## **ADDENDUM #1**

**June 25, 2014**

Re: Harrisburg Area Community College  
Lancaster Welcome Center Renovations  
Solicitation # RFB15-01

From: Eastern PCM, LLC  
Construction Manager – HACC  
645 N. 12<sup>th</sup> Street, Suite 200  
Lemoyne, PA 17043

SK- A030.01

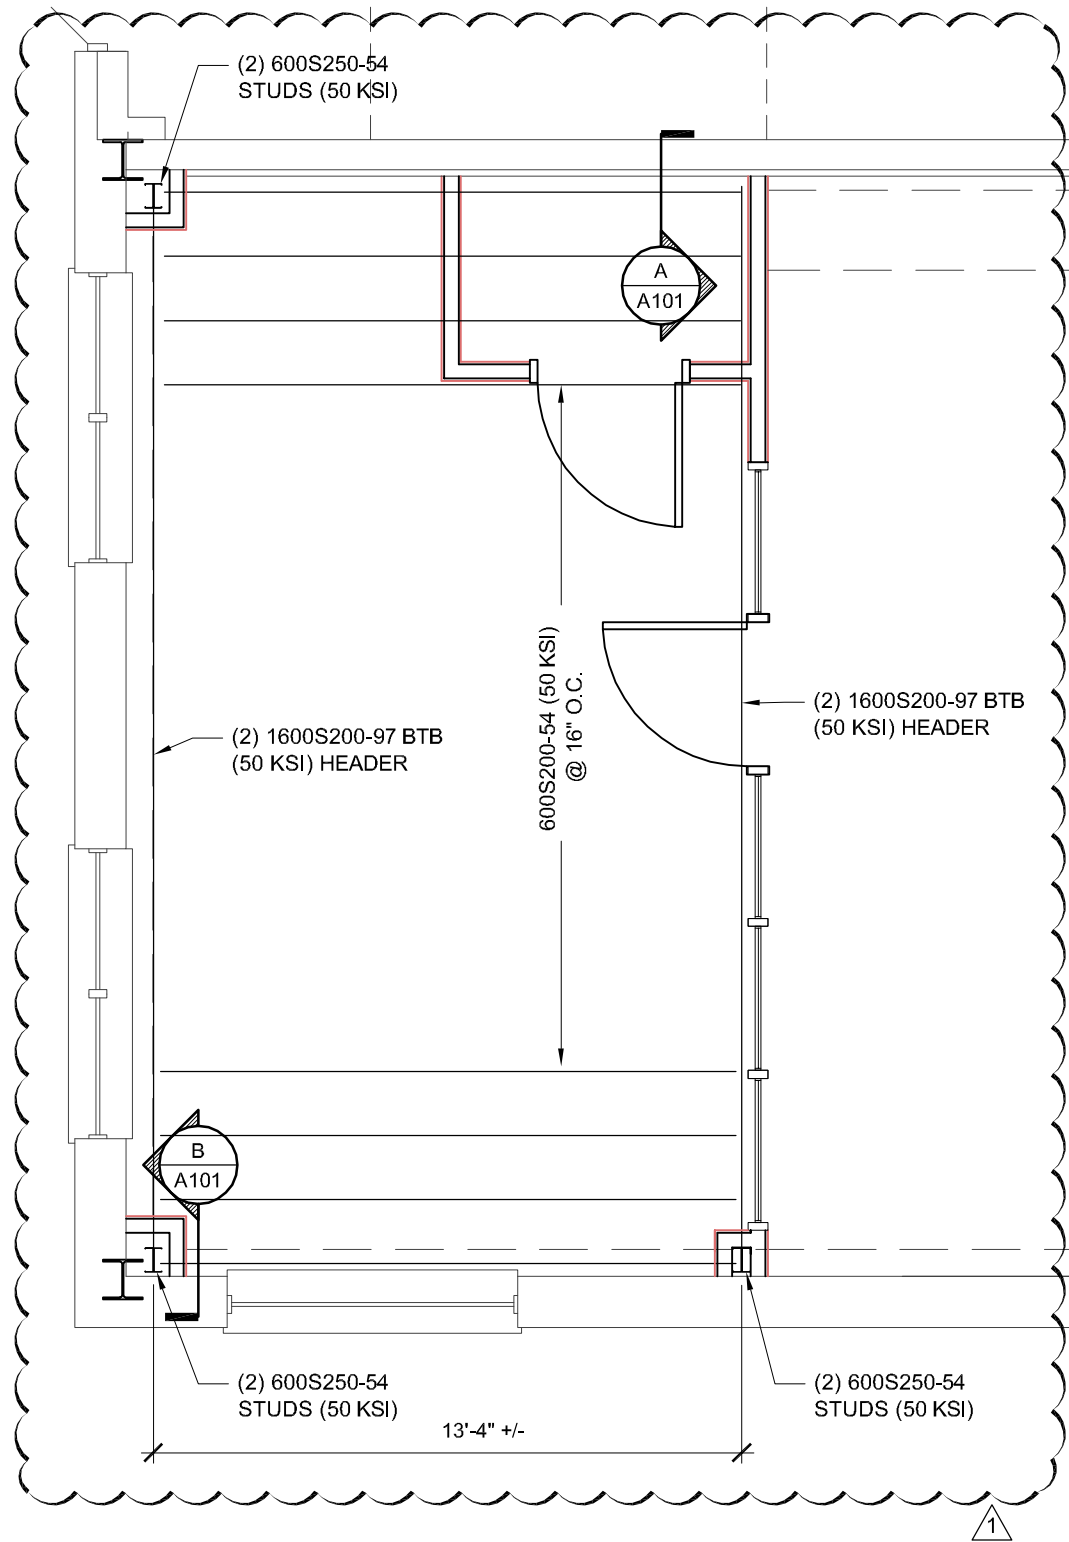
3. **REVISE** Detail 1: Overall Plan – Demolition per SK-A030.01.

1. **REVISE** Demolition Note 16 to read:

“Remove floor trough drain and cap drain line. Infill opening to match existing. Refer to Plumbing Demolition Plan for locations of all floor openings to be infilled.”

2. **REVISE** Demolition Note 18 to read:

“Remove quarry tile floor as required so that there is a minimum ¼” below the existing adjacent concrete subfloor at corridor near the elevator and stairwell. Due to the slope of the floor, some areas may not have to be disturbed if already at or below ¼” minimum requirement to the existing adjacent concrete subfloor. Clean and prime subfloor (or existing tile) as recommended per manufacturer’s warranty. Pour a minimum ¼” thick self leveling concrete to match existing adjacent subfloor level at corridor near the elevator and stairwell.”

SK- A101.01

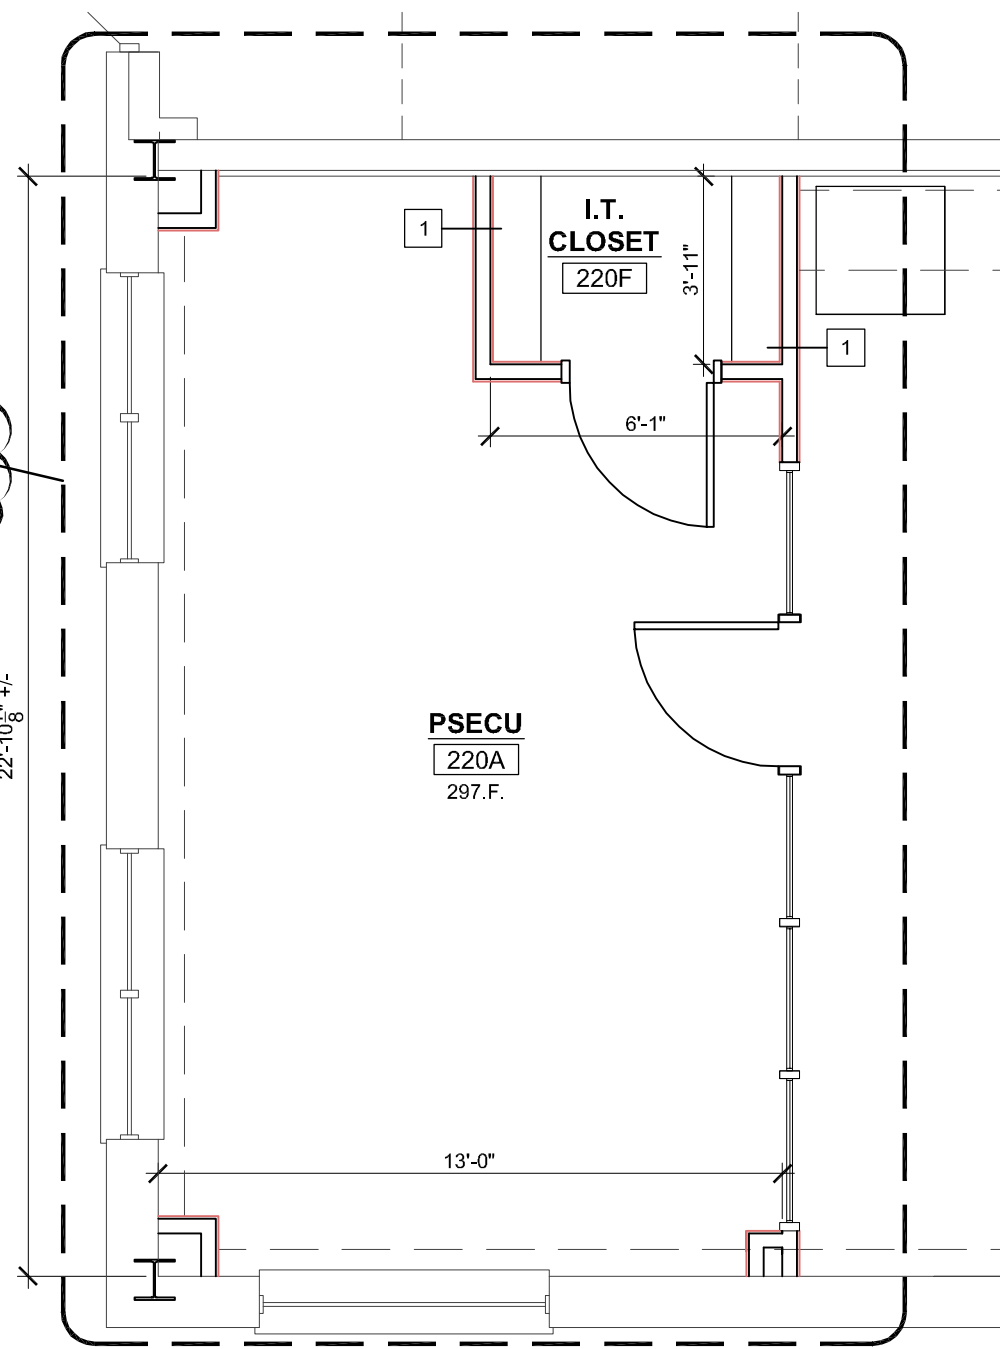
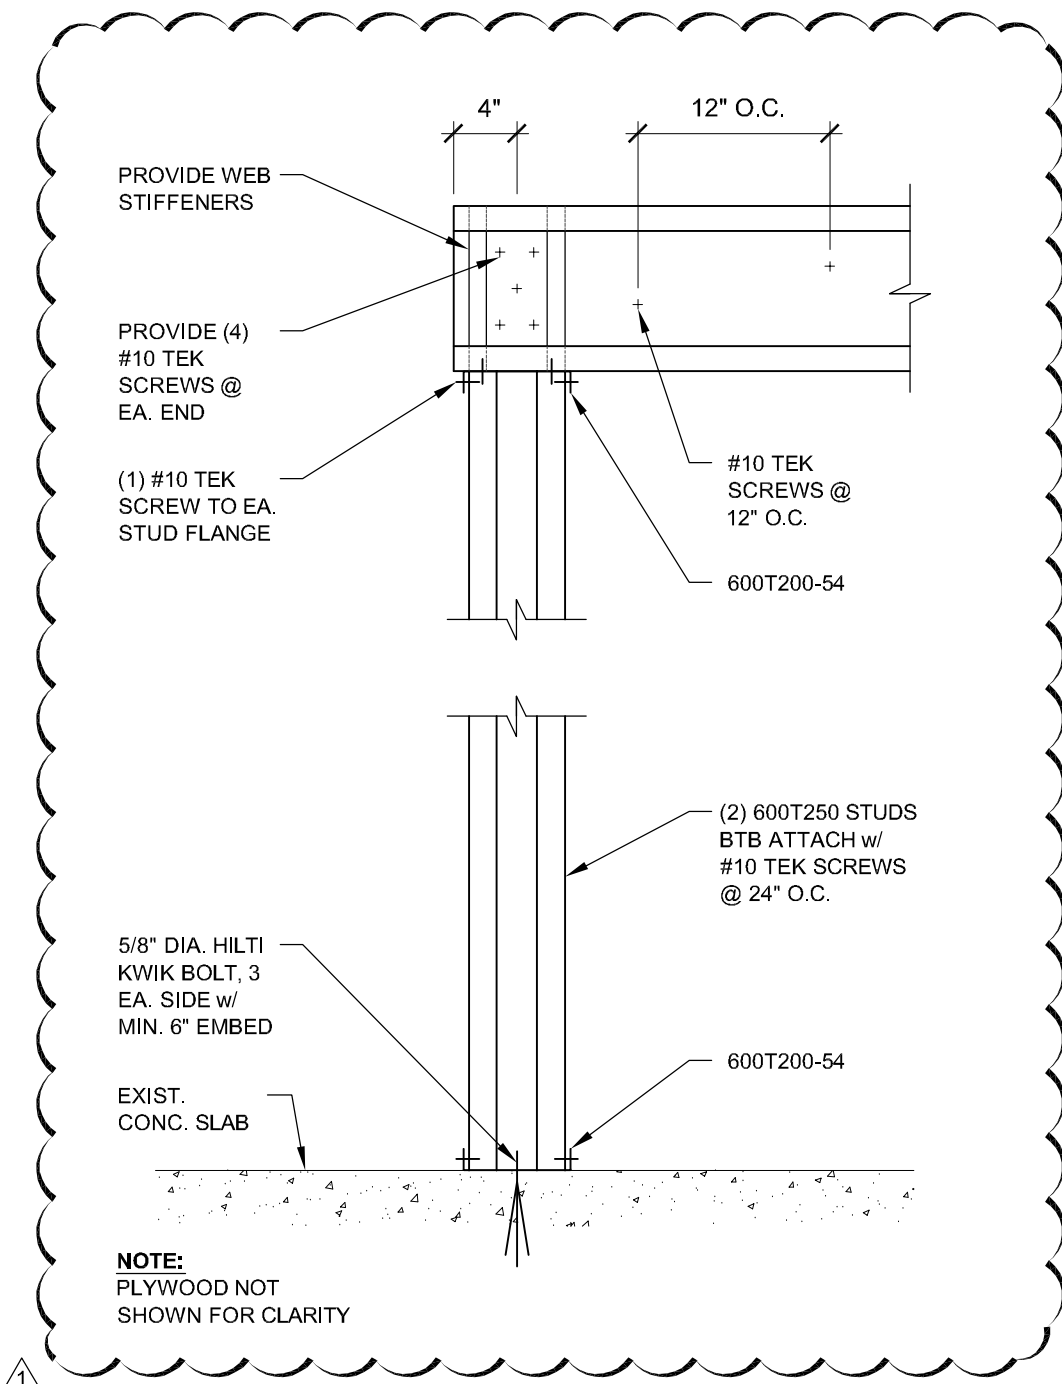
1. **REVISE** Detail 1: Enlarged Floor Plan per SK-A101.01.

2. **ADD** Detail 5: Structural Framing Plan per SK-A101.01.

**SK-A101.02**

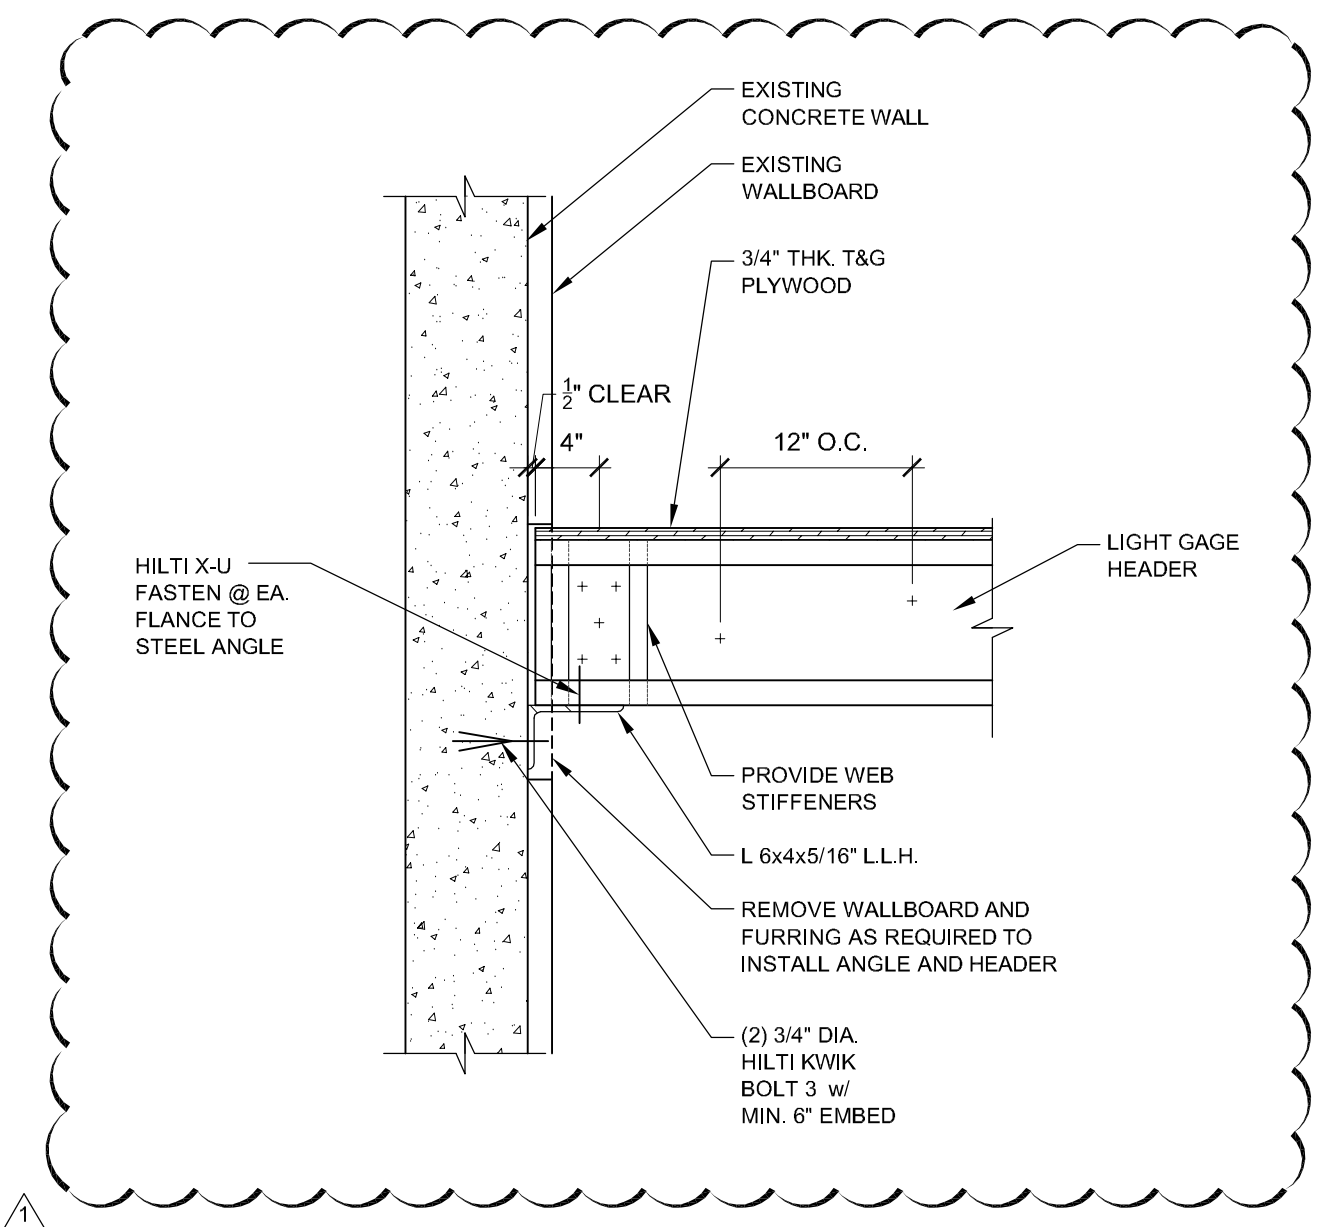
3. **ADD** Detail A per SK-A101.02.

4. **ADD** Detail B per SK-A101.02.
